Discussion.

THE BRABAZON ASSEMBLY HALL AT FILTON.

Fig. 29 (a).

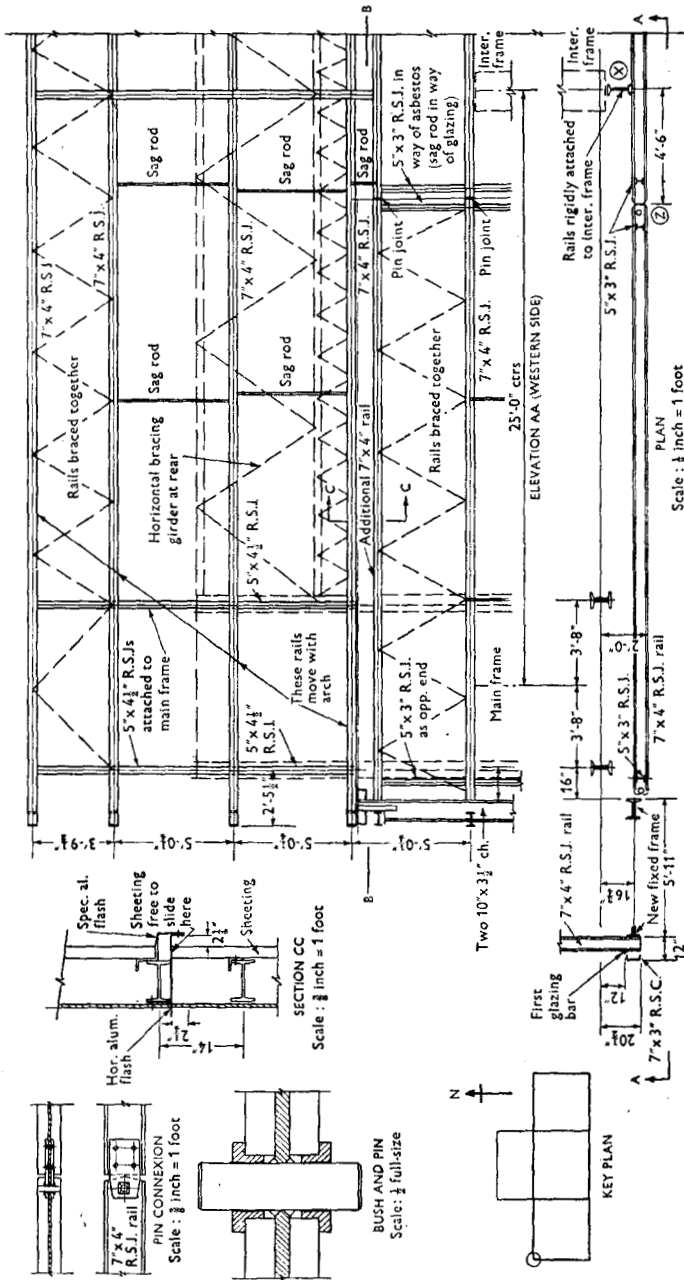
Figs 29 showed a key plan and certain details of the solution at the corner ringed in the key plan. It should be understood that the wind-pressure arising from the design velocity of 75 miles per hour caused an anticipated sway of the structure of ± 5 inches at tie-level. In view of the fact that it was thought necessary to maintain the framing for the glazing on the north walls absolutely rigid, it was apparent that provision for considerable differential movement at tie-level should be made at the northern corners.

Figs 29 (a) showed the general arrangement adopted from approximately tie-level downwards. At point X the sheeting rails were fixed to the arches subject to sway up to the intermediate frame next to the end arch (the northernmost arch in the Western Bay). At point Y the main frame formed part of the glazing supports and was not subject to sway.

Therefore, arrangements were made to cantilever out, in order to reduce the span of the sheeting rails, from point X to point Z, and to fix the last section of sheeting rail to that connected to the intermediate frame by means of a pin joint at that point, the other end of the link being fixed by another pin joint at point Y. That arrangement permitted a full parallel sway movement of ± 5 inches of the rail in a direction perpendicular to the line ZX, the rail on line YZ acting accordingly with fixed fulcrum at Y. The maximum angular movement to be permitted between YZ and ZX to safeguard the sheeting against fracture was estimated at 1 degree of angle. The linkage itself was shown at the top left of *Figs 29 (a)*.

Figs 29 (a) included a general elevation of that arrangement which applied line BB downwards. Above line BB it was necessary to alter the arrangement to ensure continuity in roof sheeting and gable; that was done by means of the sliding joint and flashing shown in section CC. *Fig. 29 (b)* showed how the arrangement was carried along the north wall with provision for the sheeting above DD to move relative to the lower part. The bulb angles shown were fixed to the main tie and therefore were subject to upward and downward movement with load; thus they could slide vertically on the fixed stanchion of the glazing framework.

Fig. 30.

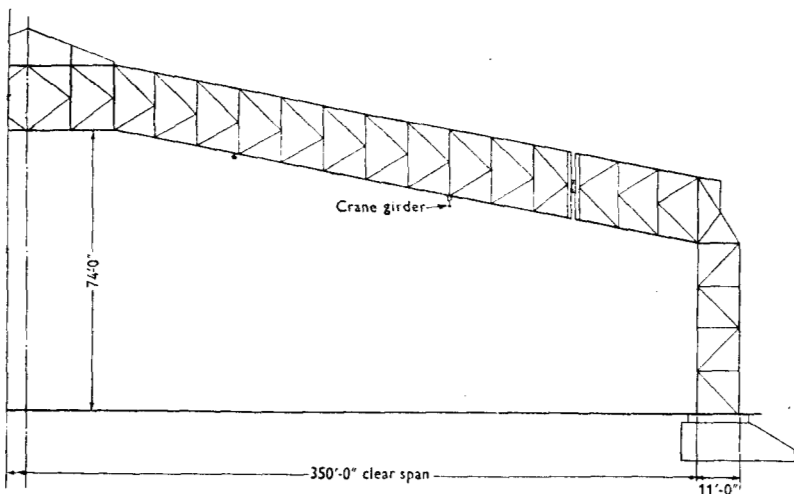
He considered that the problem might have been solved by the introduction of a structure on the lines shown in *Fig. 30*, with the pins in the air. The virtue of that was that the vertical towers and the cantilevers could be erected and tied back and it would probably be possible to erect the central portion in one portion riveted complete on the ground. Again, the same design could have been adapted to meet the multiple-span condition at Filton simply by reflection.

Another alternative which might have been adopted if the design with the pins above haunch-level had been considered would have been to make the central portion of light alloy, to save erection charges, and to keep the vertical parts in steel in order to reduce the lateral deflexion.
